TECHNICAL BULLETIN

Jaguar Assist Module – USA Vehicles Only –
Install Later Revision Level –
Service Action S140

MODEL 2001 MY
S-TYPE
VIN L86902-M21959

Remove and destroy Bulletin S419-S140, dated 12/01.
Replace with this Bulletin.
Revisions are marked with a bar and in **bold text**.

ILLUSTRATION 1

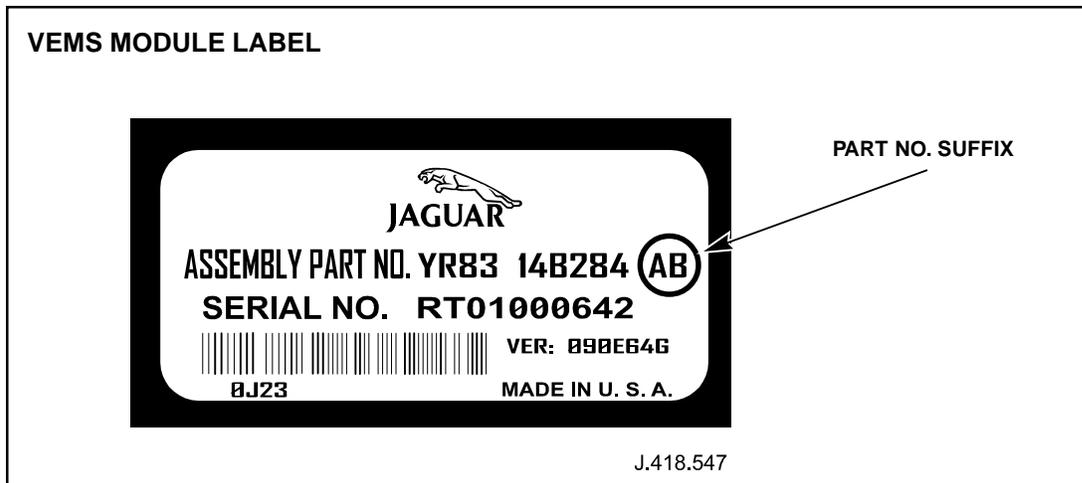
5. Remove satellite navigation system support bracket bolts.
6. Displace satellite navigation system support bracket. Locate the VEMS module and inspect the label (Illustration 1). If the label indicates an AA suffix, continue with the procedure on the next page.

If the label in Illustration 1, indicating an AB suffix to the part number, is present on the module you will need to make the activation call using the Jaguar Assist System. The upgrade will be completed automatically. The word "UPGRADED" must be marked on the label to indicate that the upgrade has been completed.

If the label in Illustration 1, indicates an AA suffix to the part number, continue as follows:

7. Reinstall satellite navigation support bracket.
8. Reinstall satellite navigation control module.
9. Reconnect battery and reset all customer preferred settings noted in step 4.
10. Refit luggage compartment carpet.
11. Remove fender protector covers.
12. Close luggage compartment.

7. Disconnect Jaguar Assist control module (VEMS module) electrical connector.
8. Remove Jaguar Assist control module.
9. Install new Jaguar Assist control module.
10. Reconnect control module electrical connectors.
11. Reinstall satellite navigation support bracket.
12. Reinstall satellite navigation control module.
13. Reconnect battery and reset all customer preferred settings noted in step 4.
14. Refit luggage compartment carpet.
15. Remove fender protector covers and close luggage compartment.
16. Verify that JTP759 issue 11 or later is installed, and connect the WDS to the vehicle.
17. Complete module configuration program using the WDS.
18. Once reprogramming is complete, disconnect the WDS from vehicle.
19. Place a call to the ATX center to verify system operation.
